Product Change Notice (PCN)

PCN Number: **PCN-053-9036R-01**

Product(s) Affected: **CBL-UC-UC-1**

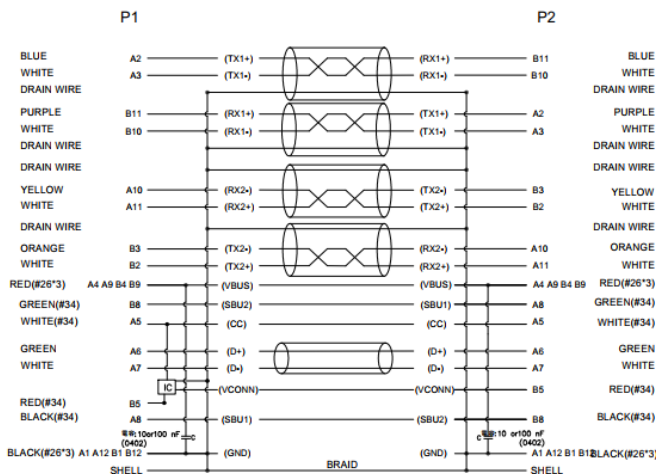
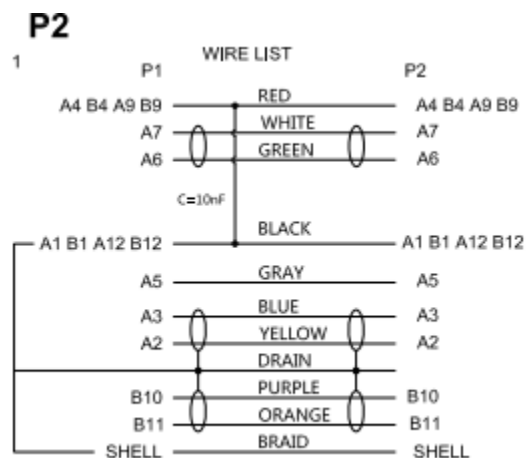
Description of Change: **Wiring Pinout configuration change. IC chip added to VCONN connection.**
